ADDENDUM NO. 2

PACIFIC HIGH SCHOOL – NEW ADMINISTRATION BUILDING

SAN BERNARDINO CITY UNIFIED SCHOOL DISTRICT

DSA No. 04-119637 File No. 36-H7 RCA Job No. 1-78-28

DSA APN #: 04-119637
DSA File #: 36-H7
Date: 4-20-2021
Project #: 1-78-28
Sheet #: **ASK-2.1**

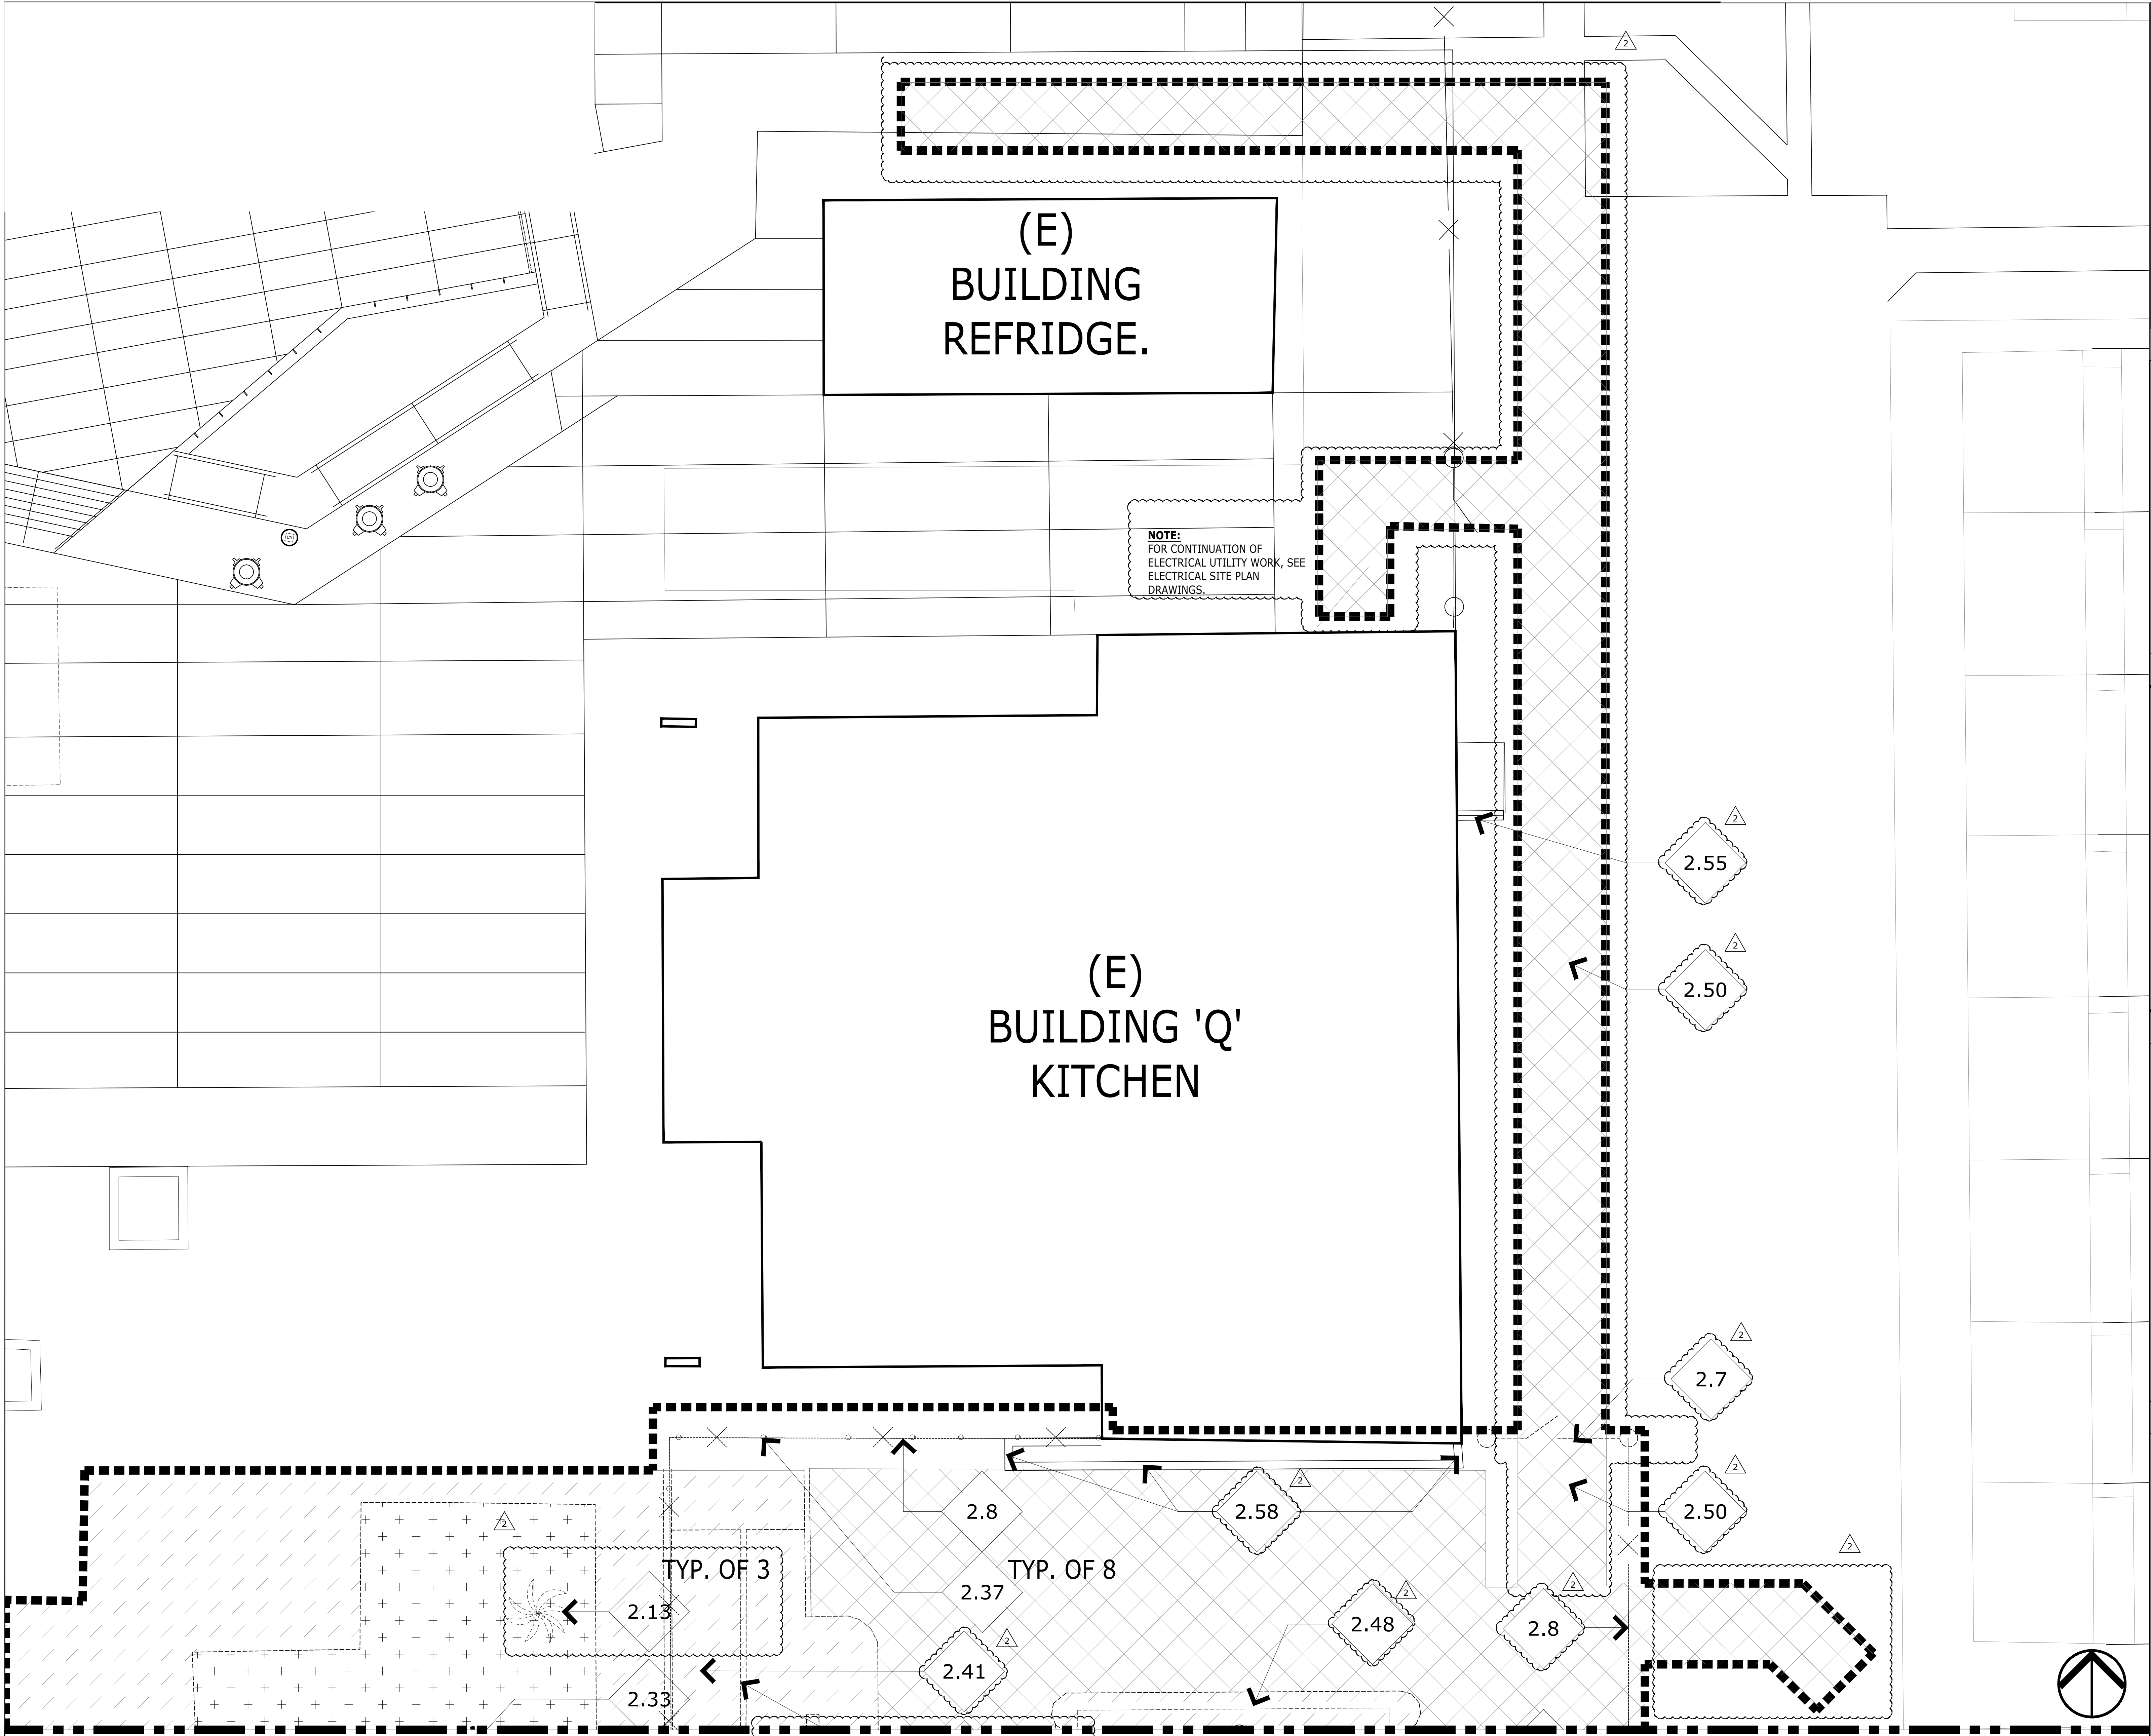
- Item No. 2.8 Reference Sheet A-1.1:
 - 2.8.1 Add new room signage per clouded area of attached Sketch **ASK-2.1**
- Item No. 2.9 Reference Sheet A-4.1:
